AMENDED IN RED

PLANS AND DOCUMENTS referred to in the **PDA DEVELOPMENT APPROVAL**

Approval no: DEV/2018/989

EVERLEIGH SIGNAGE

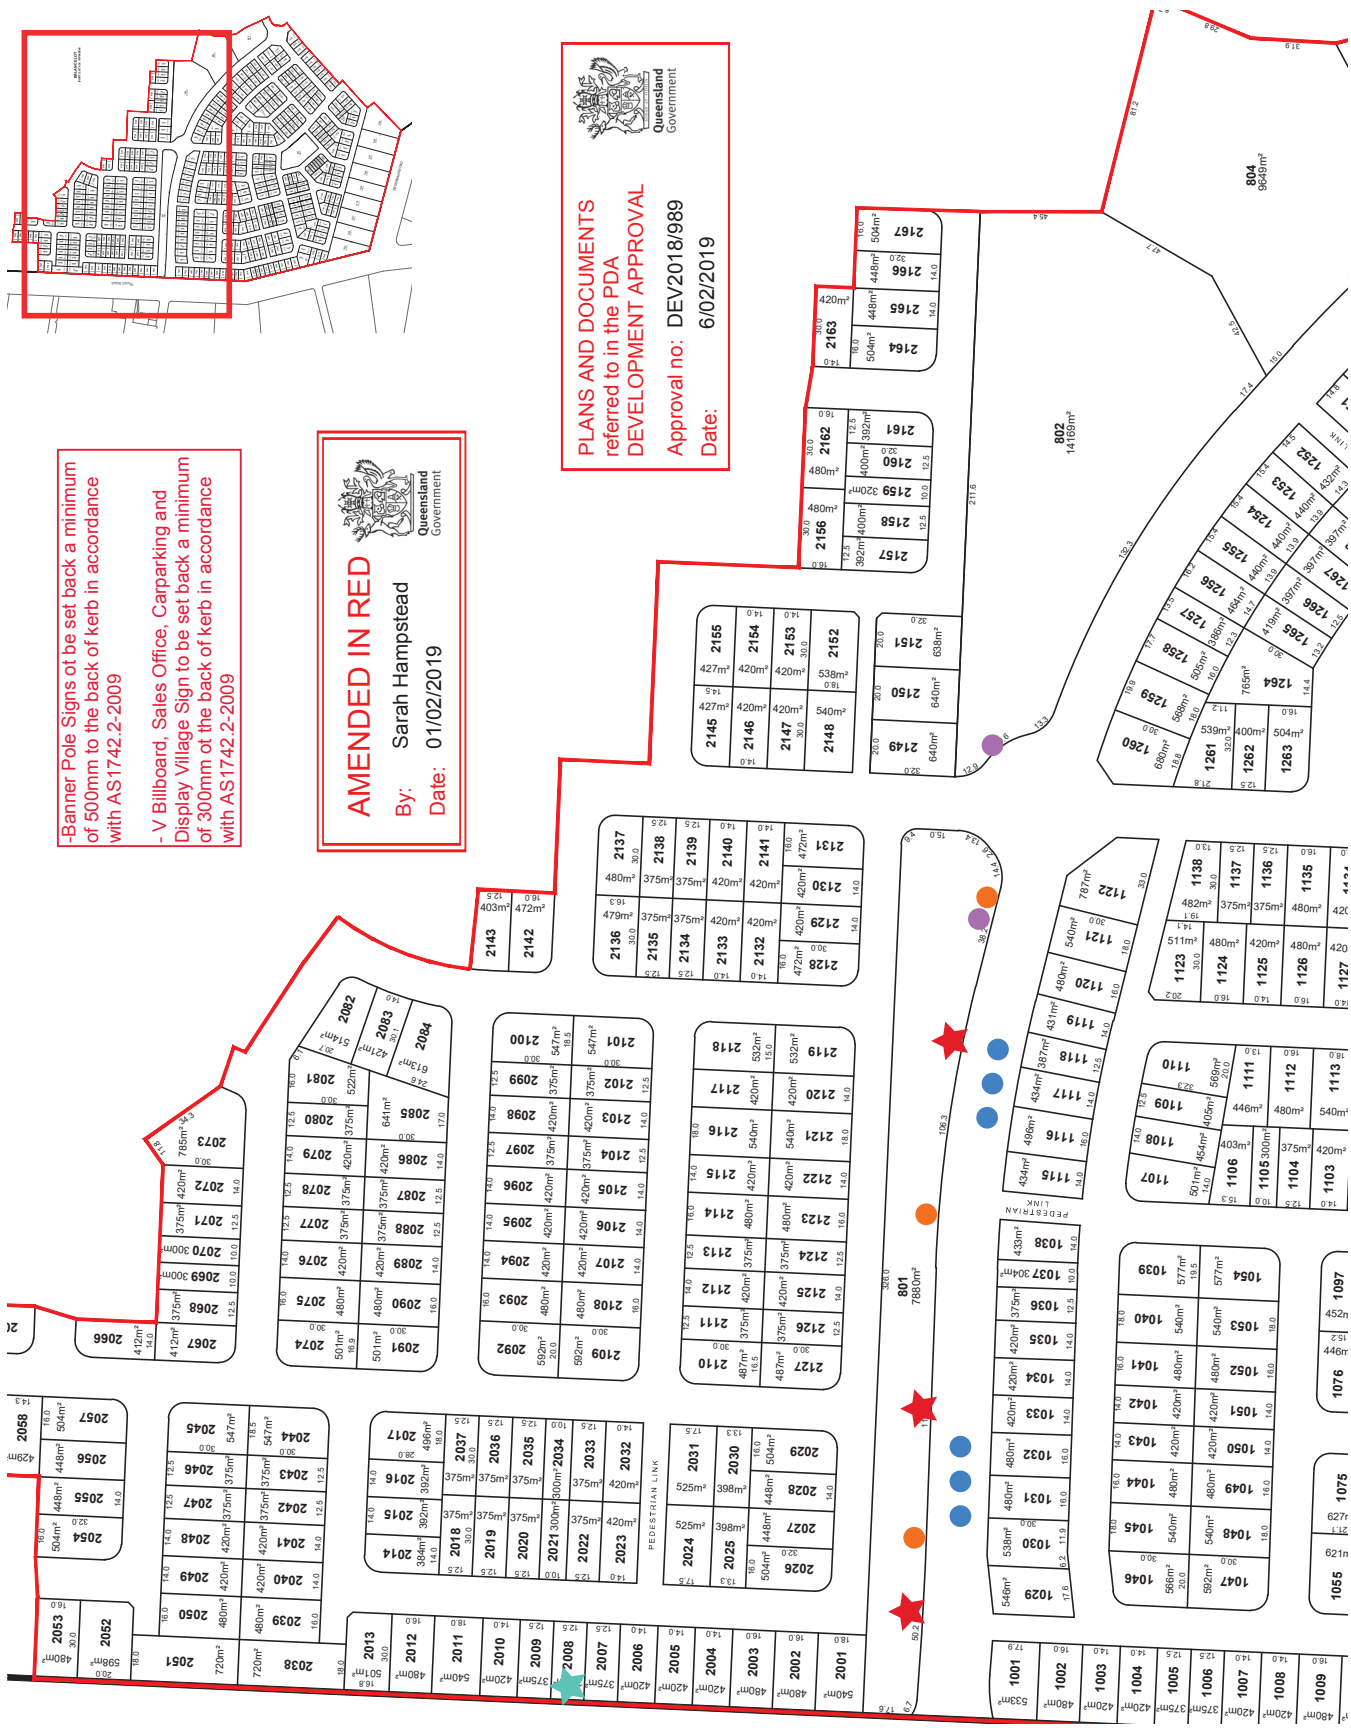
-Banner Pole Signs to be set back a minimum of 500mm to the back of kerb in accordance with AS1742.2-2009

- V Billboard, Sales Office, Carparking and Display Village Sign to be set back a minimum of 300mm of the back of kerb in accordance with AS1742.2-2009
